ORDINANCE NUMBER: O6-5-A

**-----
An Ordinance Adopting the "Subdivision Ordinance of Vermilion Parish,
Louisiana"**

SUBDIVISION ORDINANCE

VERMILION PARISH, LOUISIANA

FIGURE 1
TYPICAL HARD-SURFACED STREET SECTION
 Vermilion Parish Subdivision Regulations
 (Not To Scale)

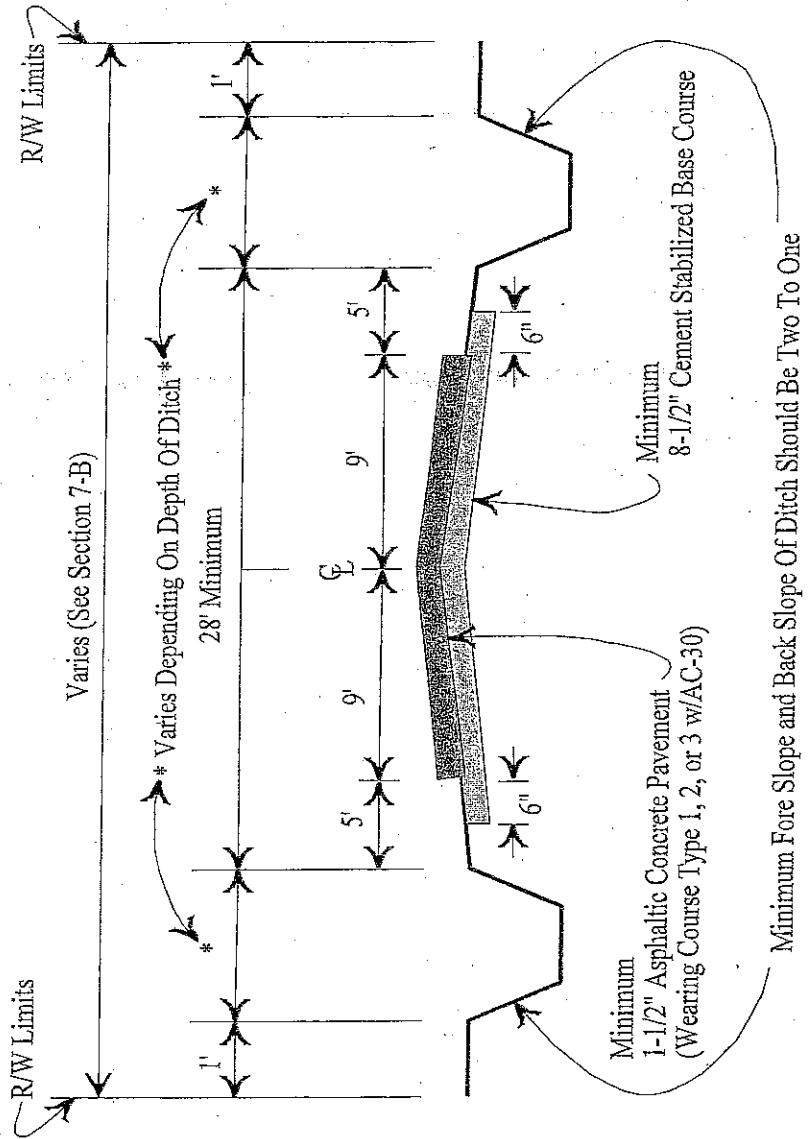
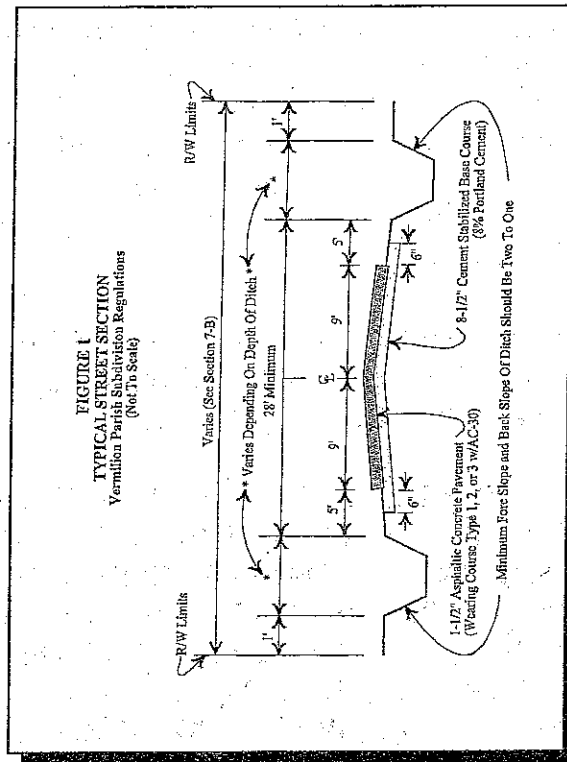
All streets must be graded not less than twenty-eight feet (28') in width from shoulder edge to shoulder edge (See Figure 1). Shoulders shall not be less than five feet (5') in width and the improved roadway not less than eighteen feet (18') in width and adequately ditched. The roadway improvements shall consist of one and one-half inch (1-1/2") thick asphaltic concrete pavement wearing course (Type 1, 2, or 3 using AC-30 asphalt) and to a width of not less than eighteen feet (18') with a minimum eight and one-half inch (8-1/2") cement stabilized base course (cement content to be determined by an independent testing laboratory along with lime requirement needed for cement stabilization) to a width of not less than nineteen feet (19') or other approved base course (See Typical Hard-Surfaced Street Section).

Minimum right-of-way limits required will be based on the following open ditch depths for all street improvements:

DITCH DEPTH (Feet)	MINIMUM RIGHT-OF-WAY LIMITS (Feet)
0 - 2	50
3	60
4	70
Greater than 4	75

FIGURE 1
TYPICAL HARD-SURFACED STREET SECTION
 Vermilion Parish Subdivision Regulations
 (Not To Scale)

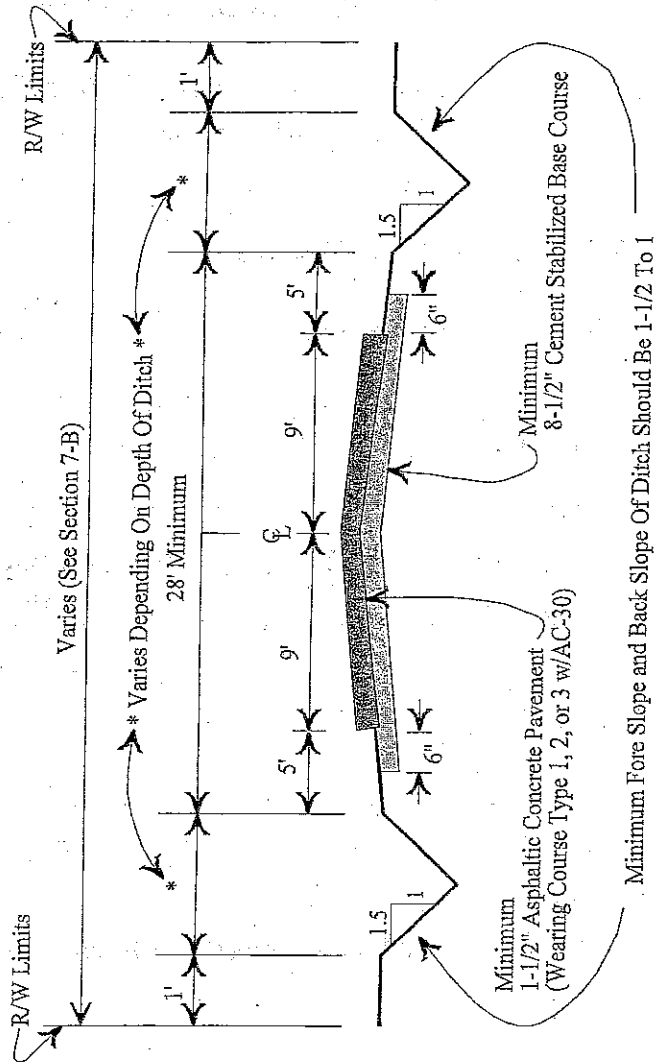
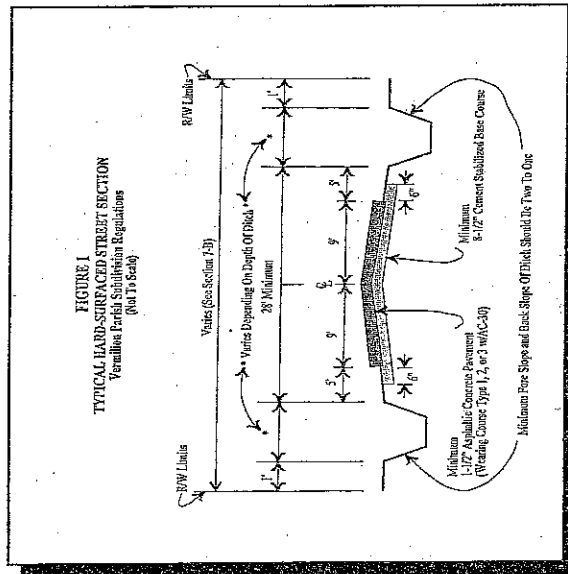
Revise the Table and Figure 1 in Subsection B - "Street Improvements", to read as follows:

DITCH DEPTH* (Feet)	MINIMUM RIGHT-OF-WAY LIMITS* (Feet)
0 - 3.33	50
3.33 - 5	60
5 - 6.67	70
Greater than 6.67	75

*For 18-Foot Road Surface
